UNITED STATES PATENT AND TRADEMARK OFFICE

APPLICATION NO.	FILING DATE	FIRST NAMED INVENTOR	ATTORNEY DOCKET NO.	CONFIRMATION NO.
09/982,928	10/22/2001	Steven M. Knowles	10765-015001	8524

Office Action Summary

DETAILED ACTION

FIG. 8
Prior Art

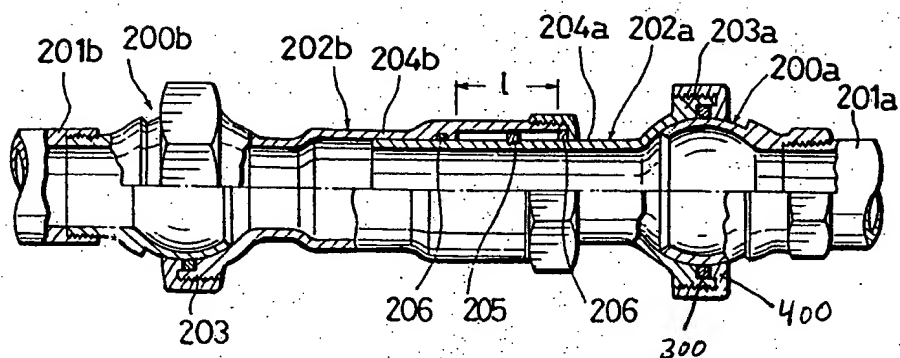
Regarding claims 1, 11 and 12, Sato discloses (figs.8 and 9) a flexible joint assembly for conducting a fluid, comprising: a joint assembly inlet (201a); a joint assembly outlet (201b); and a fluid flow path between the inlet and the outlet, the fluid flow path including: a first pivot joint (200a); a second pivot joint (200b); and a central fluid conductor (202a, 202b) fluidly coupling the pivot joints, wherein the pivot joints together appear to be capable of providing greater than 60° bend between the inlet and the outlet. Sato does not explicitly disclose that the pivot joints together provide greater than a 60° bend; however, a greater than 60° bend is within the scope of Sato’s disclosure. Further, applicant is reminded that it has generally been recognized that the

As to claim 3, Sato discloses the flexible joint assembly of claim 2 wherein each ball and socket joint comprises: a socket (300); a ball (200a) received in the socket; and a seal (300) between the ball to the socket.

As to claim 4, Sato discloses the flexible joint assembly of claim 3 wherein each ball and socket joint further comprises a compressing member (400) axially compressing the seal between the ball and the socket.

As to claim 5, Sato discloses the flexible joint assembly of claim 4 wherein each compressing member comprises a retaining ring (ring portion of 40 in contact with seal (300) compressing the seal between the ball and the socket.

As to claim 13, Sato discloses a flexible joint assembly comprising: a joint assembly inlet (201a); a joint assembly outlet (201b); and a fluid flow path between the inlet and the outlet, the fluid flow path including: a first pivot joint (200a); a second pivot joint (200b); and a central fluid conductor (202a, 202b) fluidly coupling the pivot joints, each of the first pivot joint and second pivot joint including: an inner member (ball portion of 200a); a receiving member (203a) dimensioned to pivotally receive at least part of the inner member; a sealing member (300) sealing between the inner member and the receiving member; and a supporting member (400) supporting the sealing member substantially uniformly over the entire length of the seal between the inner member and the receiving member.

As to claim 15, Sato discloses the flexible joint assembly of claim 14 wherein each supporting member comprises an annular support (portion of 400 in contact with seal 300) having a second surface configured to mate with the first surface of the annular seal thereby supporting the annular seal substantially uniformly.

As to claims 16 and 17, Sato discloses the flexible joint assembly of claim 13 wherein: each receiving member comprises a first engagement surface (thread containing surface of 203a); and each supporting member comprises a second engagement surface (thread containing surface of 400), wherein the first engagement surface is configured to engage the second engagement

As to claim 21, Sato discloses a flexible joint assembly comprising: a joint assembly inlet (201a); a joint assembly outlet (201b); and a fluid flow path between the inlet and the outlet, the fluid flow path including: a first pivot joint (200a) configured to pivot about a first pivot (center of 200a); a second pivot joint (200b) configured to pivot about a second pivot (center of 200b); and a central fluid conductor (202a, 202b) fluidly coupling the first pivot joint and the second pivot joint, each of the first pivot joint and the second pivot joint including: an inner member

(ball portion of 200a, 200b) having a dimension in a direction substantially normal to a path through the respective of the joint assembly inlet and outlet; a receiving member (203a, 203b) dimensioned to receive at least part of the inner member; and a sealing member (300) sealing the inner member to the receiving member.
